UNITED STATES PATENT AND TRADEMARK OFFICE

| APPLICATION NO. | FILING DATE | FIRST NAMED INVENTOR | ATTORNEY DOCKET NO. | CONFIRMATION NO. |
|-----------------|-------------|----------------------|---------------------|------------------|
| 10/823,242 | 04/13/2004 | Patrick J. Garavan | H0682.70006 US00 | 4070 |

Office Action Summary

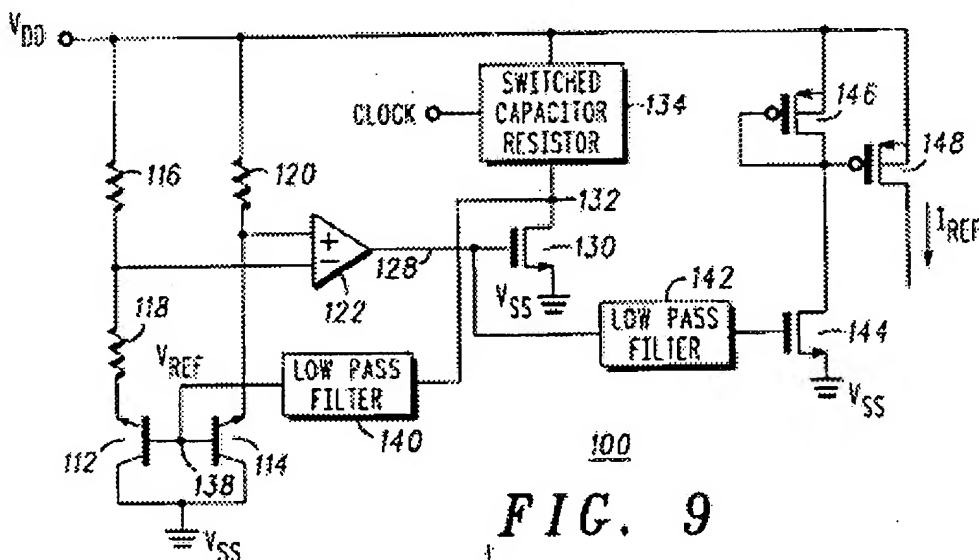
2. Figures 1 and 2 should be designated by a legend such as --Prior Art-- because only that which is old is illustrated. See MPEP § 608.02(g). Corrected drawings in compliance with 37 CFR 1.121(d) are required in reply to the Office action to avoid abandonment of the application. The replacement sheet(s) should be labeled "Replacement Sheet" in the page header (as per 37 CFR 1.84(c)) so as not to obstruct any portion of the drawing figures. If the examiner does not accept the changes, the applicant will be notified and informed of any required corrective action in the next Office action. The objection to the drawings will not be held in abeyance.
